Rezoning Transportation Analysis

Petition Number: 2025-098

Date	Description
9-24-25	First Review (NK)
10-23-25	Second Review (NK)
11-03-25	Trip Generation Update (DR)
11-25-25	Third Review (NK)

~~6+ Boulevard, 8' planting strip with 12' SUP~~

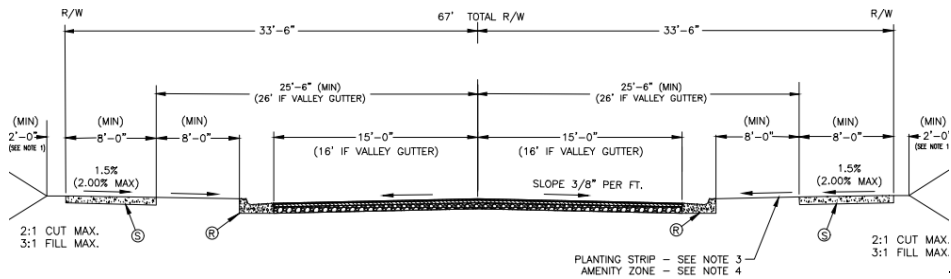
- a. ~~Pineville-Matthews Road:~~ Location of future back of curb and gutter is 44' from road centerline. Per NCDOT request, the existing curb and gutter is allowed to remain its current location.

~~Label and dimension the curb and gutter from the centerline for each road on the site plan.~~
